VKPC 86635

Technical Bulletin - September 2011

VOLVO

OE/SKF design evolution

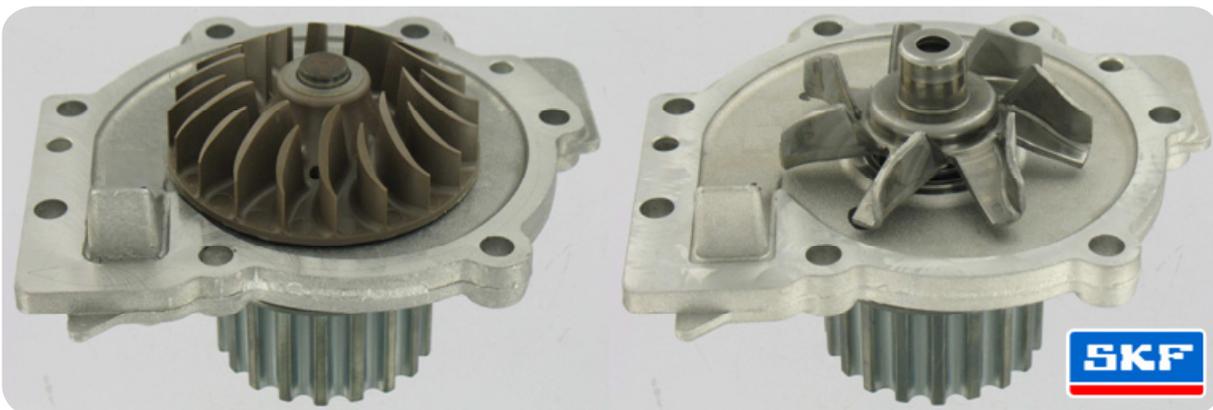
Some applications with a plastic water pump impeller have been replaced by a metal impeller. The metal impeller version of this SKF water pump, is in line with the latest OE evolution and is interchangeable with the previous OE designs.

OLD DESIGN

- OE #: 31293177
- Plastic impeller

NEW DESIGN

- OE #: 31293668
- Metal impeller

OE #: 31293177 is replaced by 31293668
